Subject: 5800/5900 Jefferson St. NE, Albuquerque, NM

Administrative Amendment Justification Letter
Minor Site plan amendment request
PR-2021-005746_SI-2021-01661
BP-2022-01598

We are requesting an Administrative Amendment for minor changes to our DRB site plan approved November 17, 2021.

Project Number: PR-2021-005746

A1 SITE PLAN - ENLARGED LOT 1B. Scale: 1" = 20'-0". Includes North arrow and graphic scale.

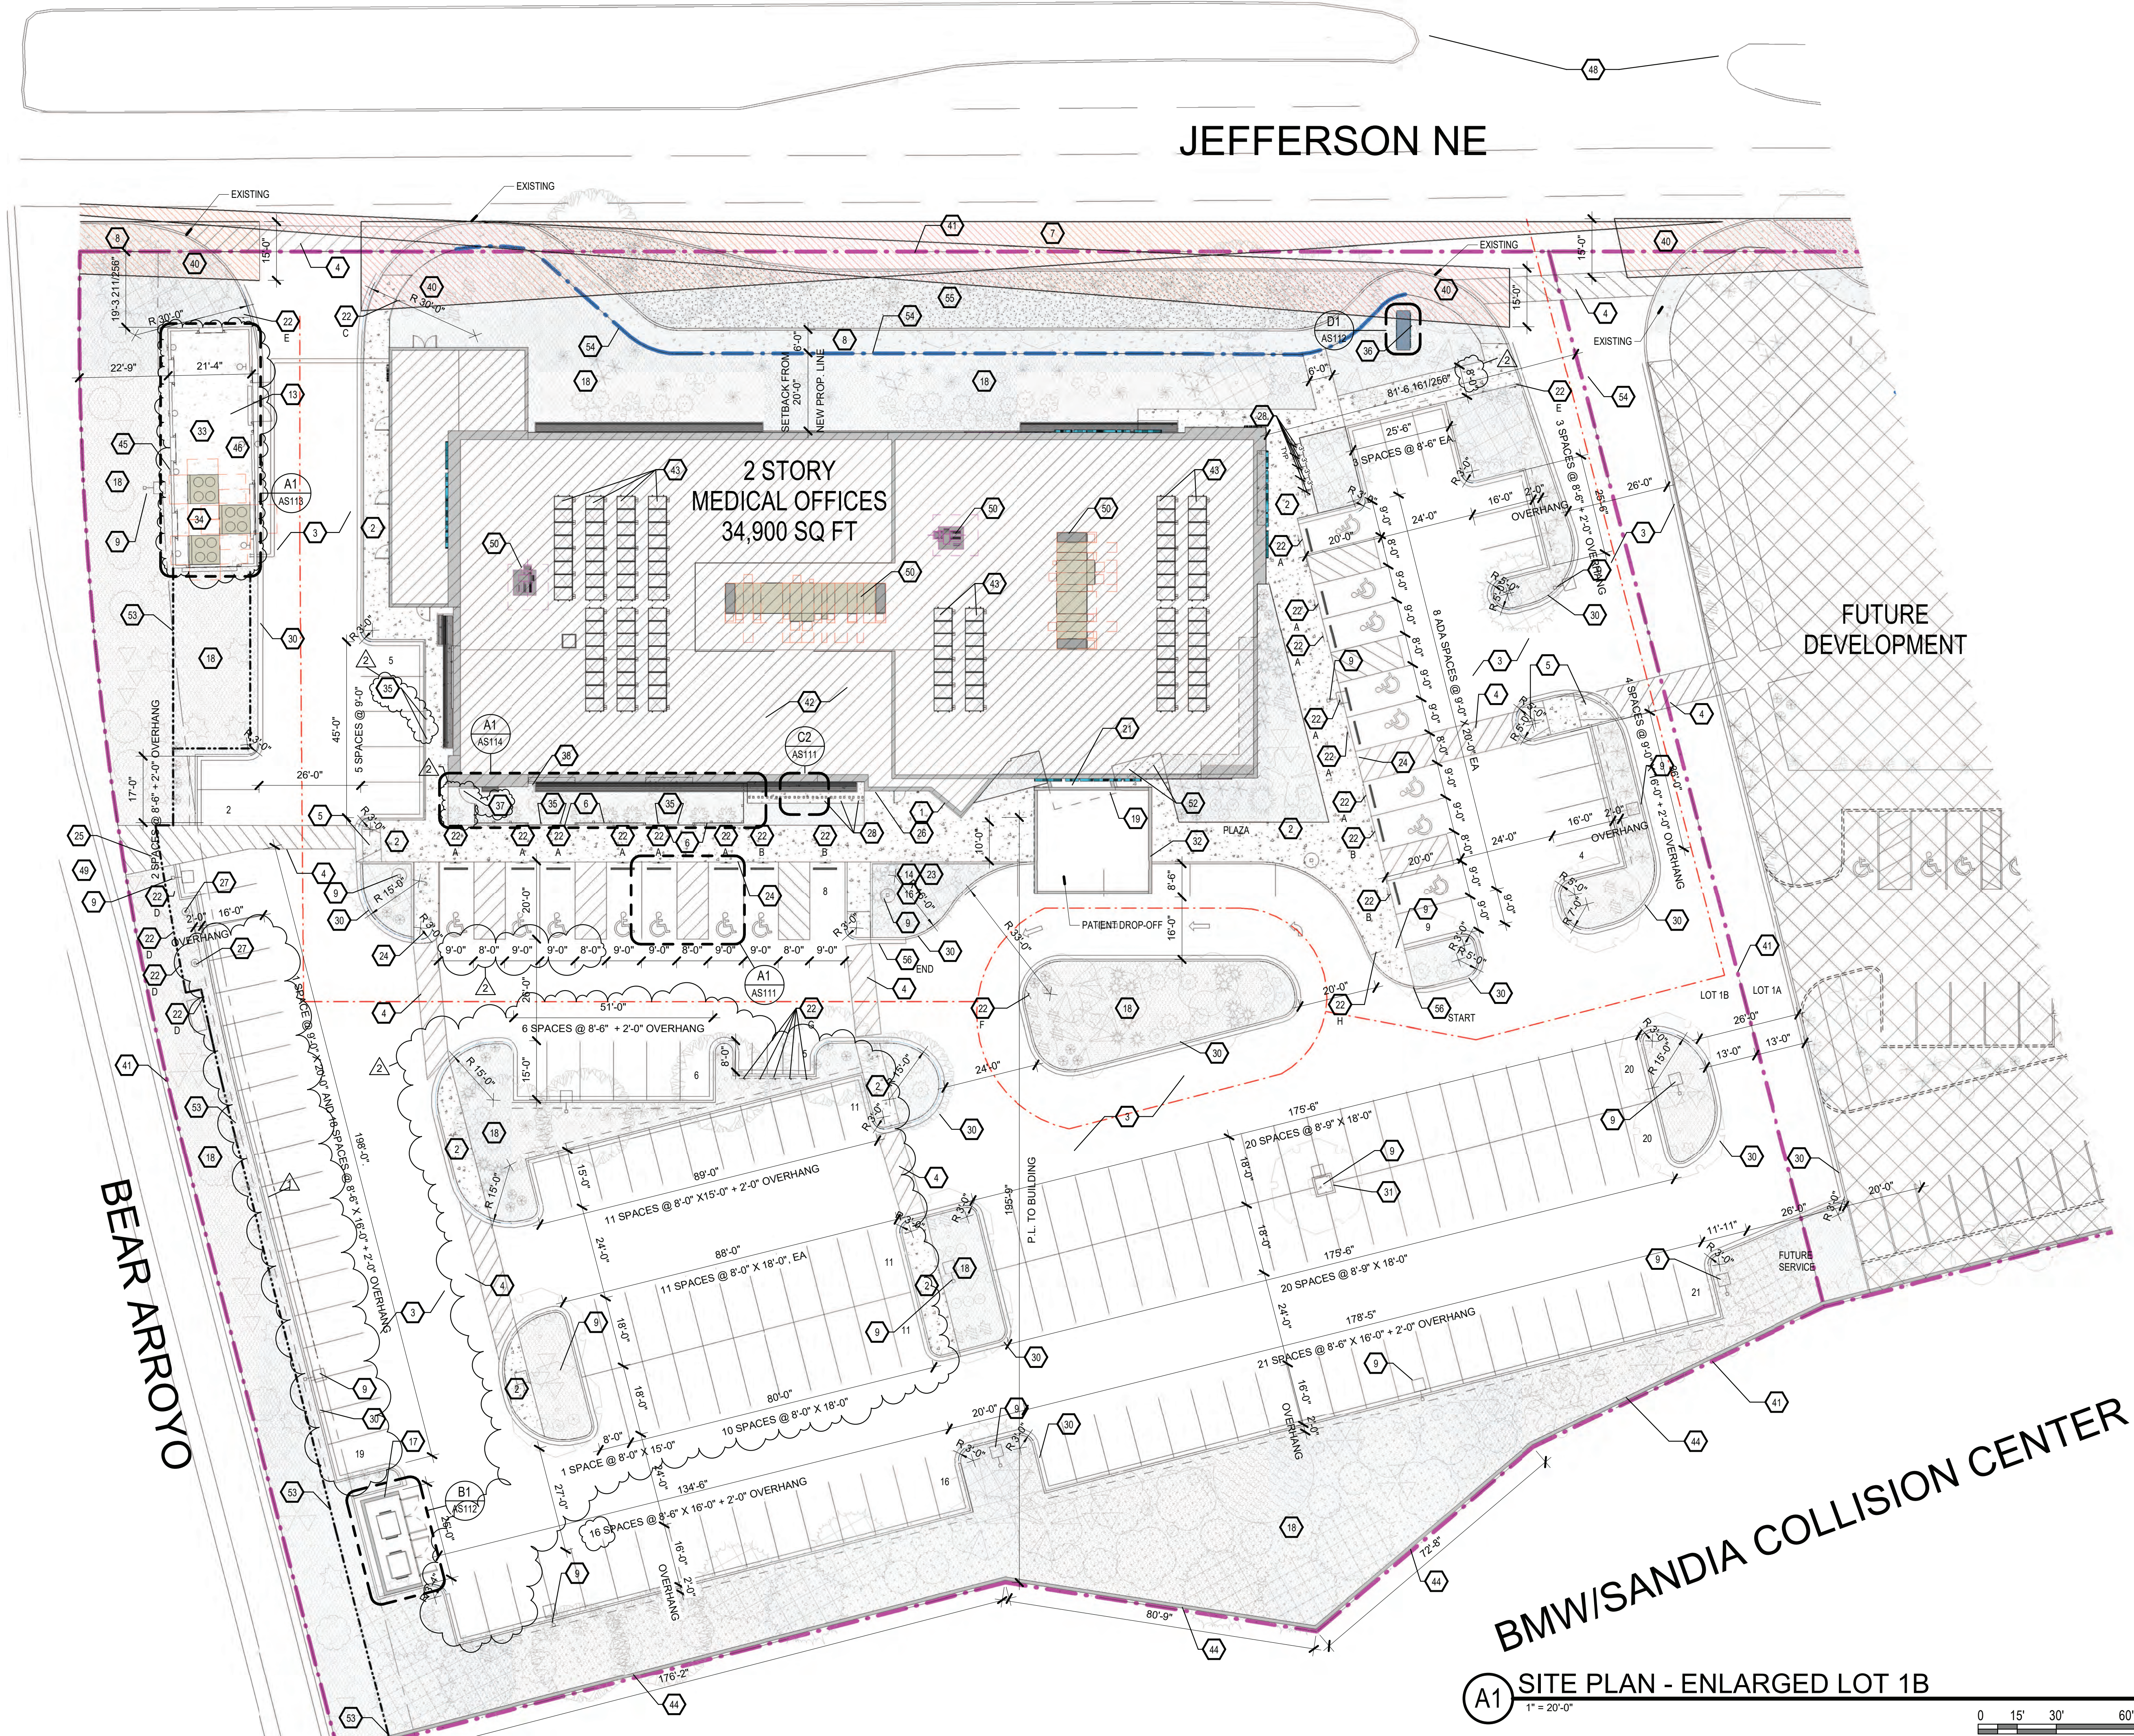
- 2(Two) Parking islands shifted 6'-0"
 - This change is the result of unavoidable/unforeseen utility complications
 - Number of parking spaces remains unchanged
 - Number of small car spaces changed from 27 to 42
 - Number of small car spaces permitted = 25% of total off street spaces provided = 173 x 25% = 43 spaces permitted
- Equipment Yard wall height has been lowered from 12'-4" to 8'-4" high
 - This change is the result of equipment being eliminated from the project
 - All of the screening criteria is still being met

SHEET TITLE
SITE DETAILS - EQUIPMENT YARD

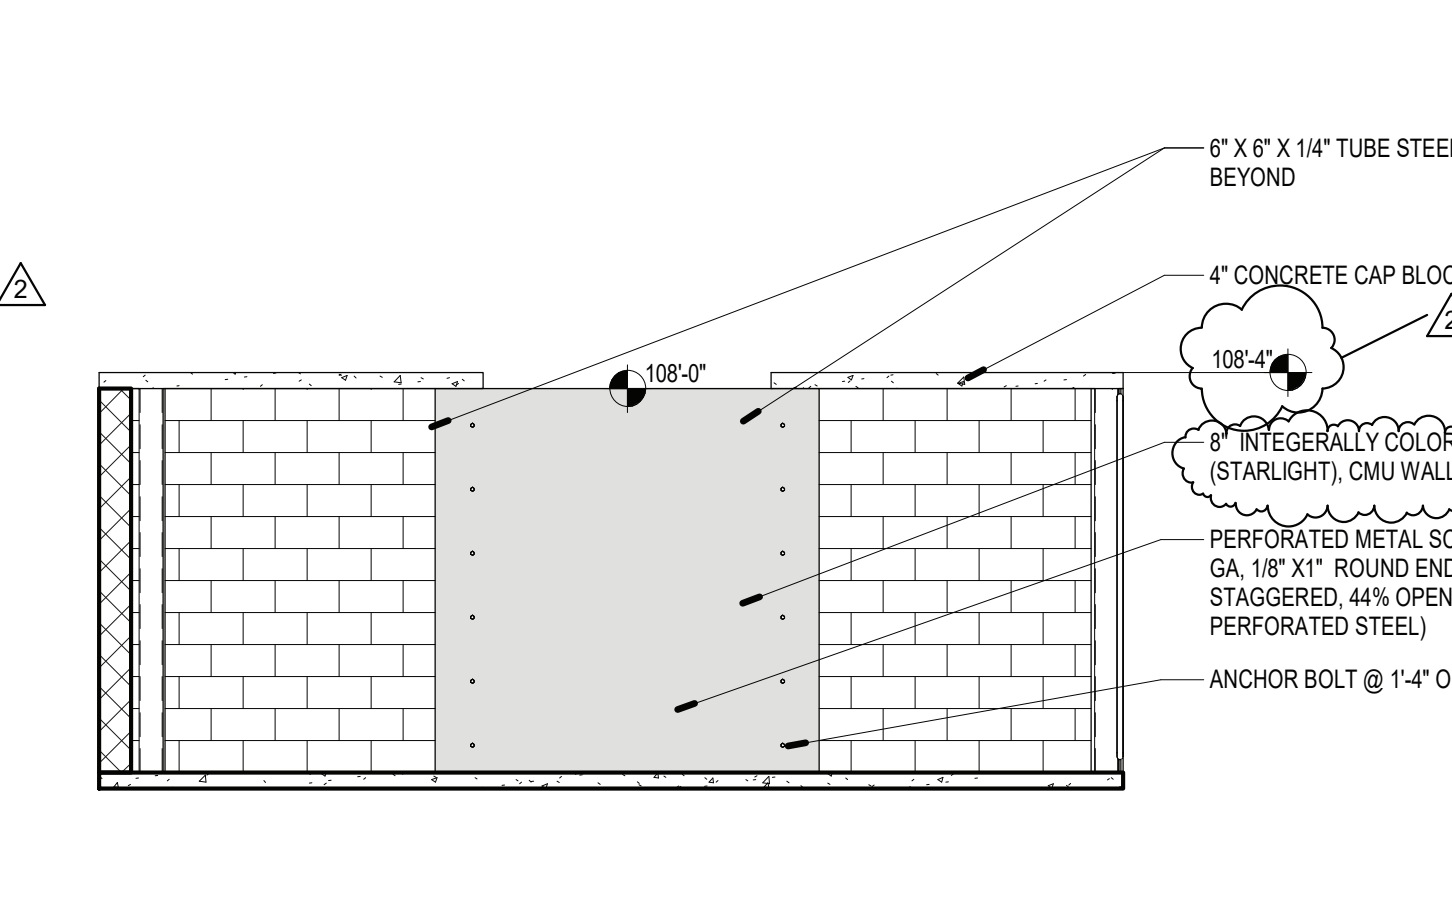
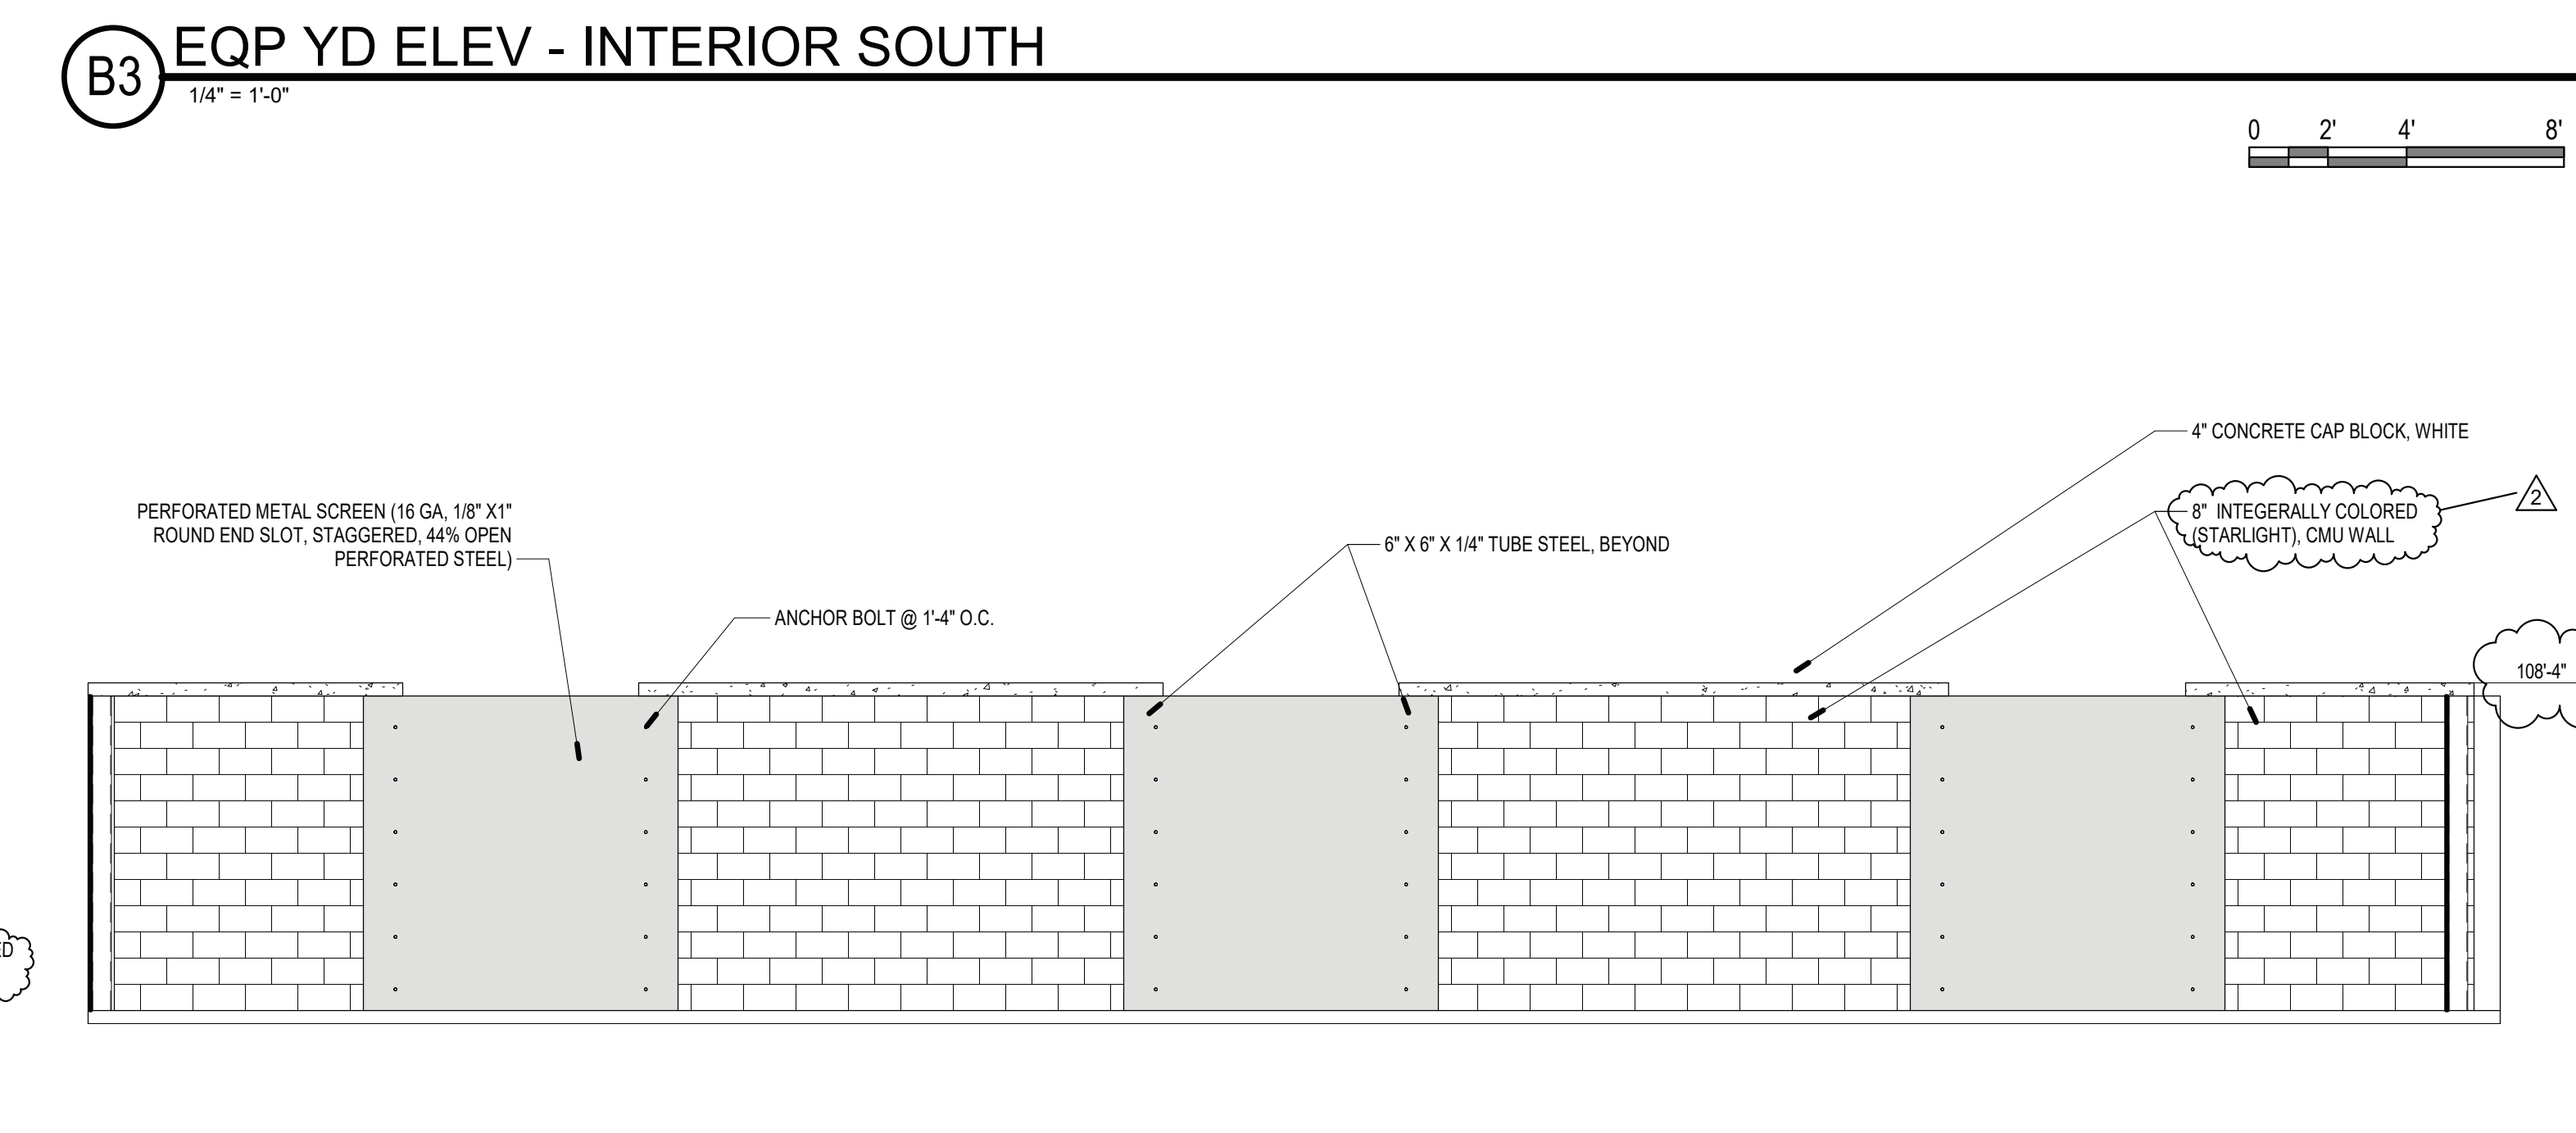
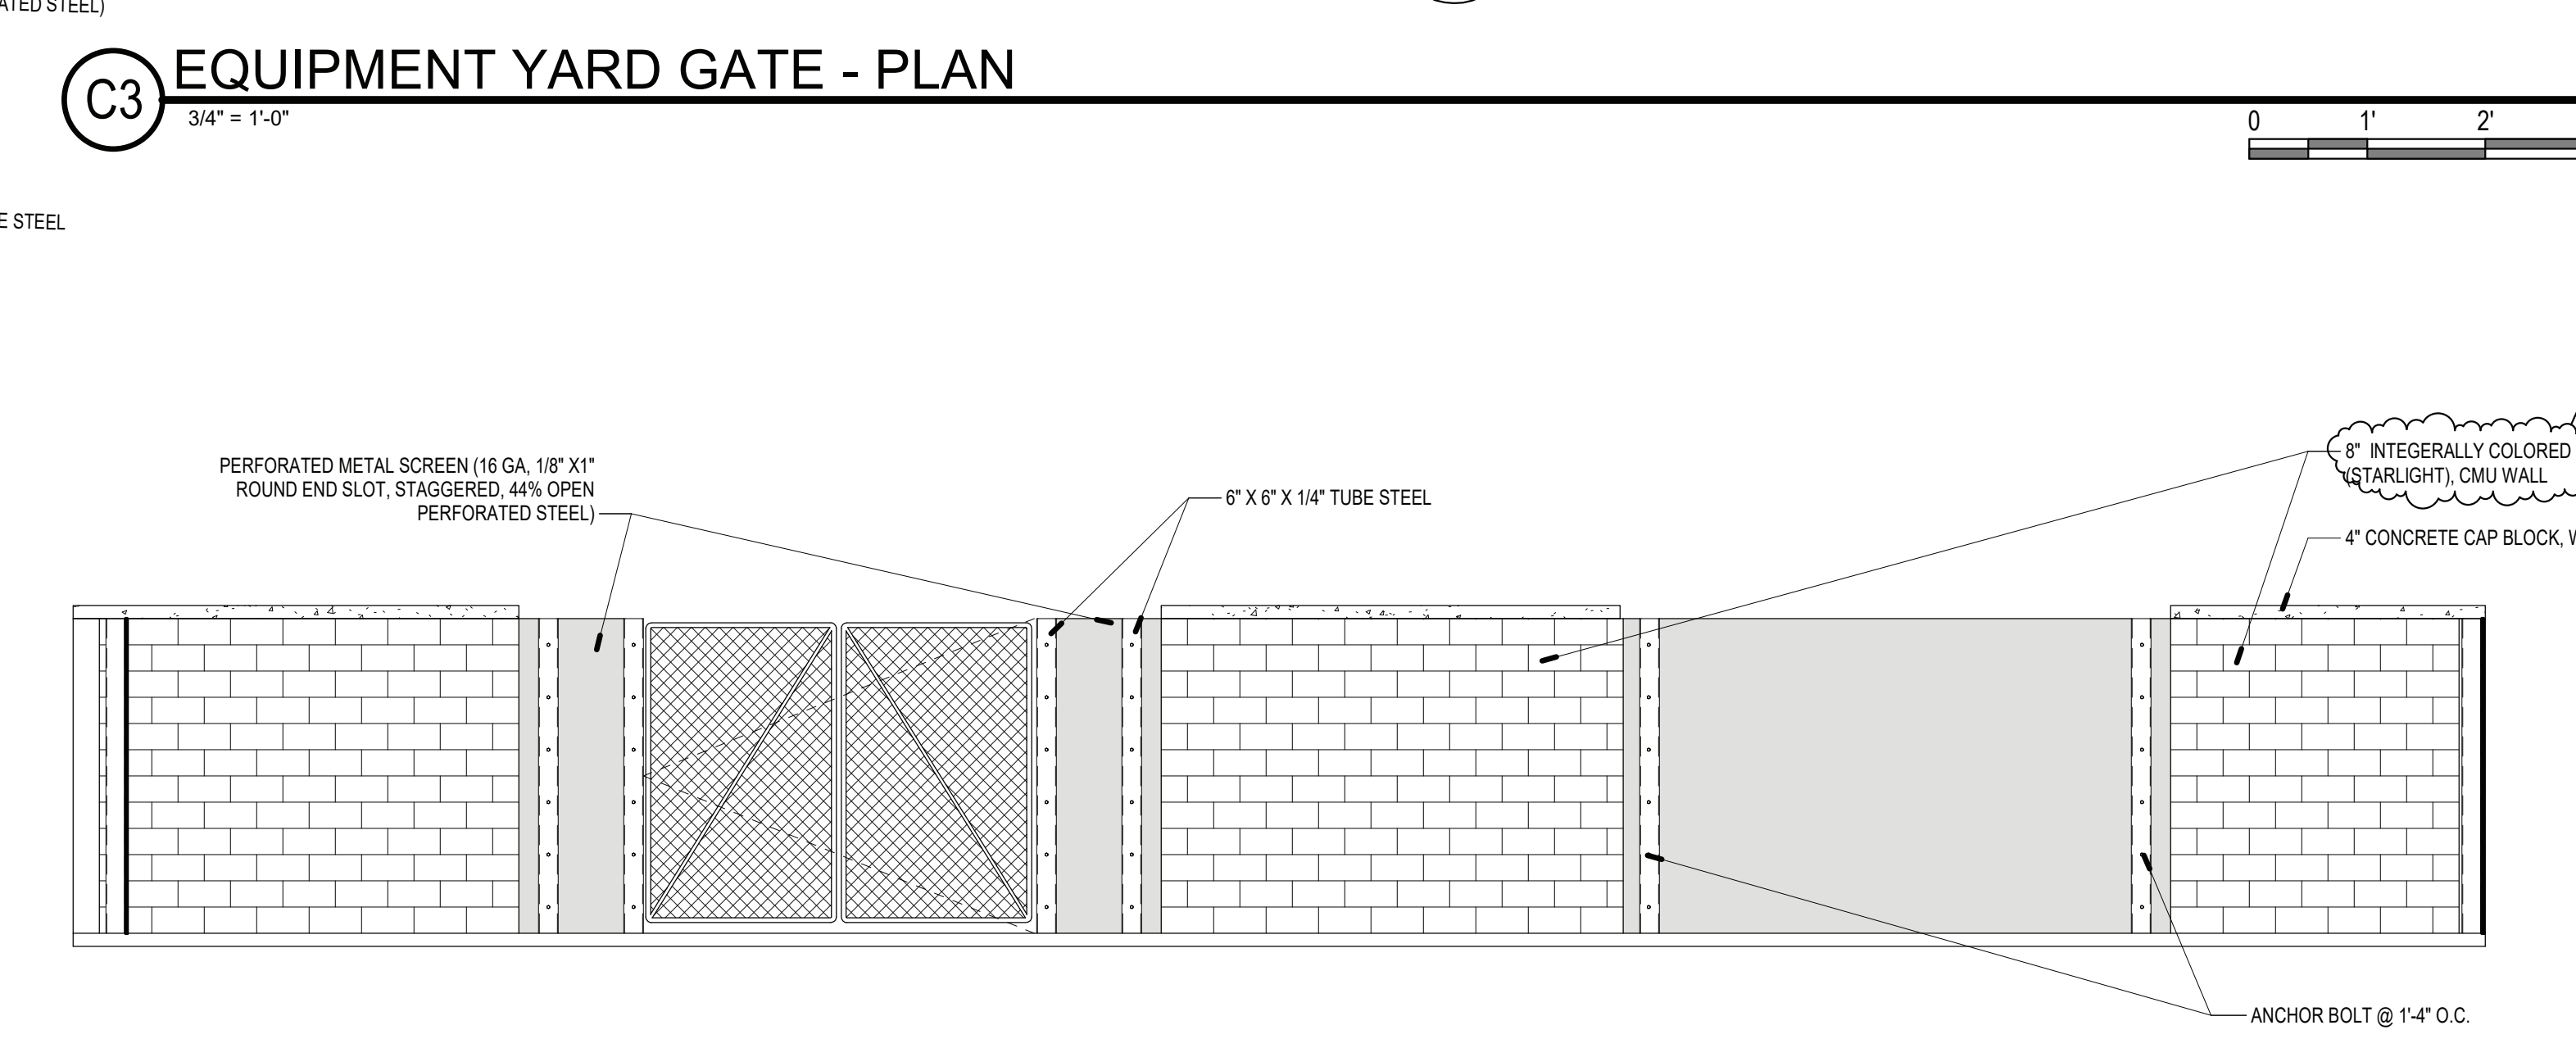
No	Date	Description
2	04/15/2022	ASI 002
Revision Schedule		
ISSUE: SHELL PERMIT		
PROJECT NUMBER: 2120		
FILE: 2120 XRANM_ARCH_Central.rvt		
DRAWN BY: CSC		
CHECKED BY: Checker		
DATE: JAN. 14, 2022
